**PRESERVE AT JONES DAIRY - CENTRAL CONSTRUCTION DRAWINGS**  
 ROLESVILLE, NC  
 LINCOLN RED DRIVE PLAN AND PROFILE

PROJECT NO: ---  
 DESIGN BY: JPE  
 DRAWN BY: RSF  
 SCALE: 1"=50'  
 DATE: 2023-01-27  
 SHEET NO: **P7.1**

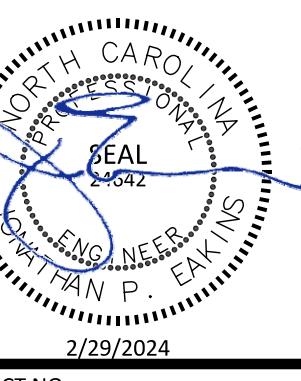
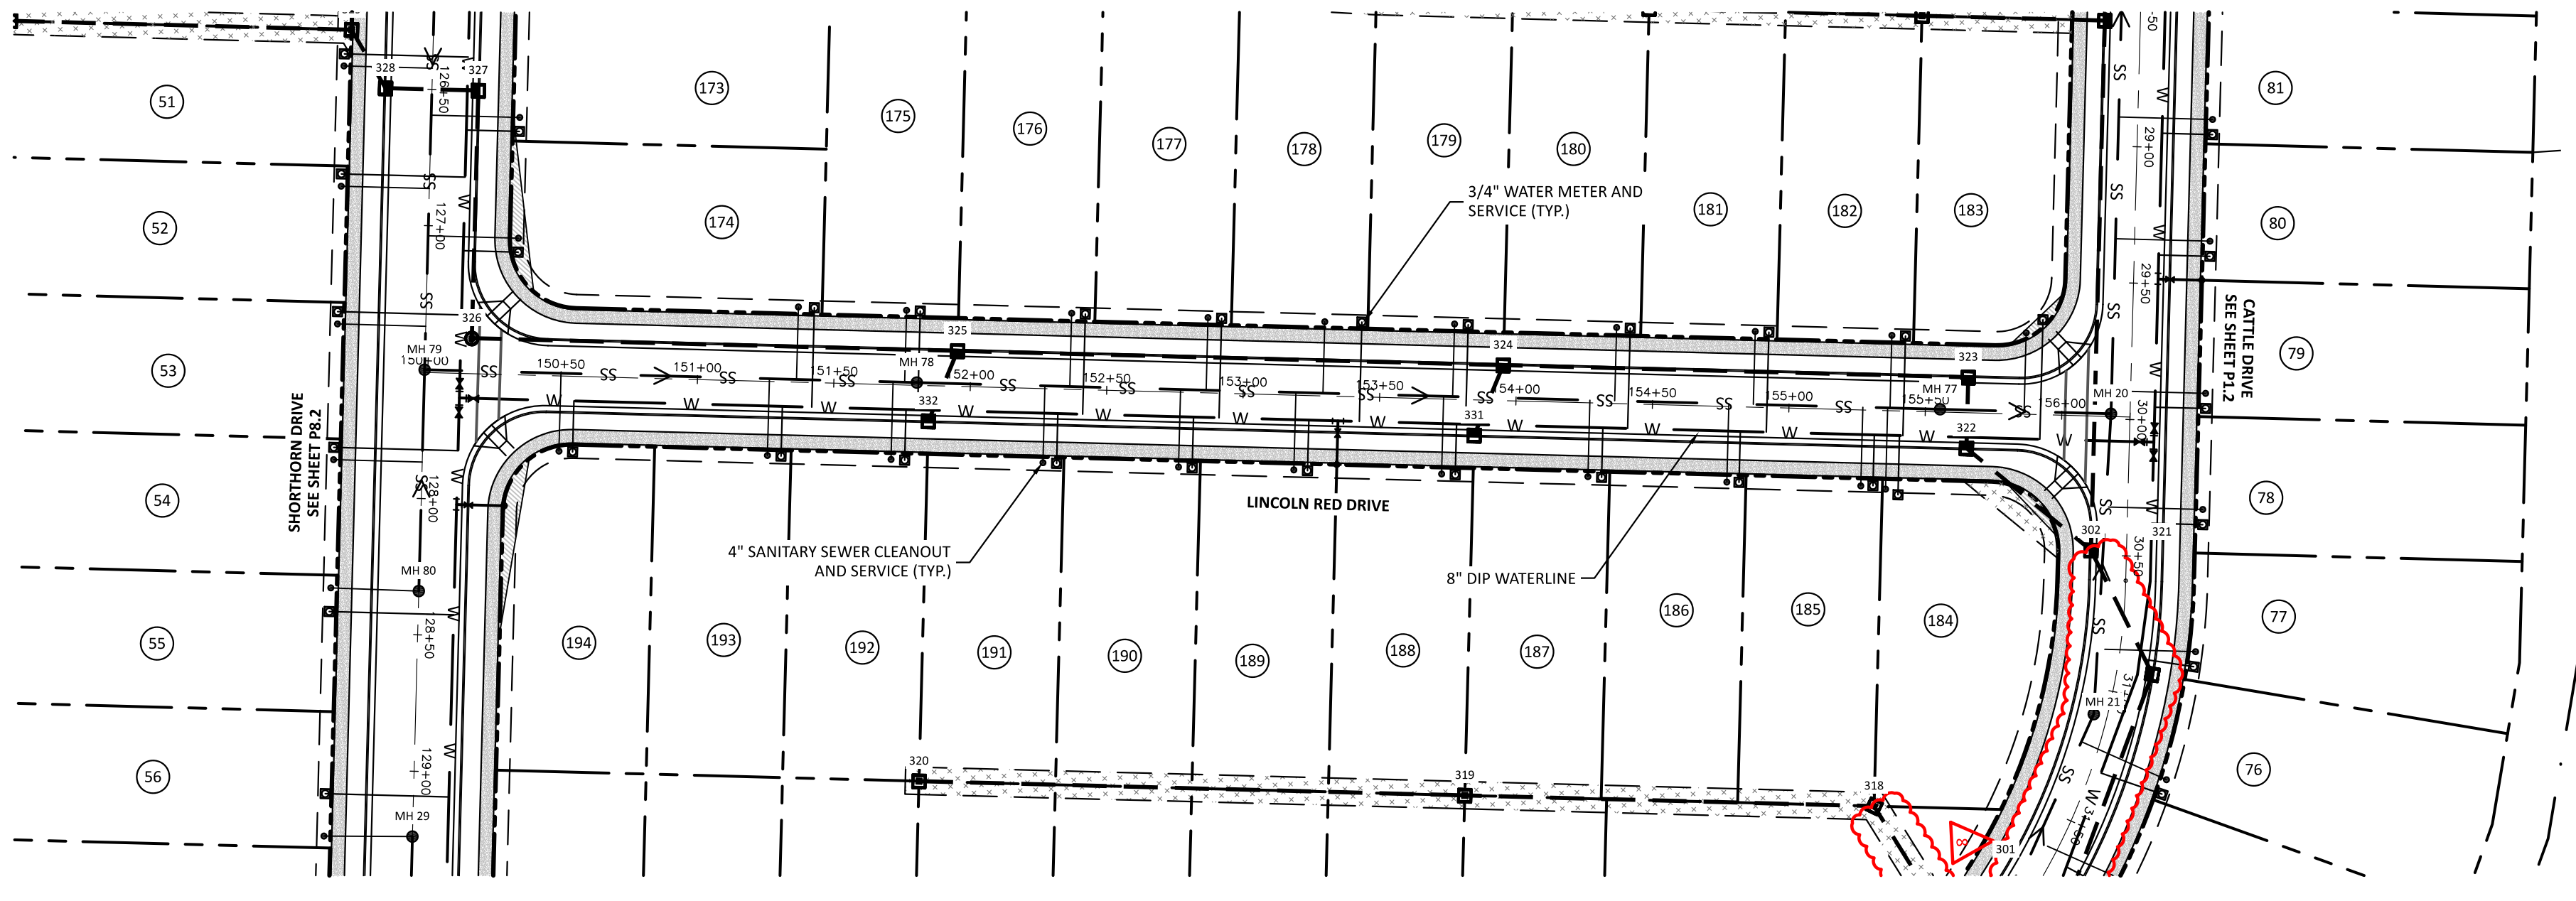
NO.	DATE	REVISIONS
1	2023-01-23	REVISED STORM IN REAR WARD ON LOTS 200-207 TO FLOW TOWARDS FIGHTING BUILDING
2	2023-01-24	REVISED PHASE LINES
3	2023-01-28	REVISED STORM PIPE DATA FROM STORM STRUCTURES LOT TO LOT
4	2023-01-28	REVISED STORM PIPE GRADING AND BEYOND FOR TOWN REVIEW COMMENTS ON STORM DRAINAGE
5	2023-01-28	REVISED POND GRADING ON LOTS 111-112 AND 217-260
6	2023-01-29	REVISED POND GRADING ON LOTS 111-112 AND 217-260
7	2024-01-19	UPDATED DAILY PROFILE FOR FRESHWATER DRIVE AND HEAD WAY CONNECTION TO FRESHWATER DRIVE
8	2024-02-29	10. STORM AND SANITARY RELATED TO REVISION OUTCALL 10.5.24.2
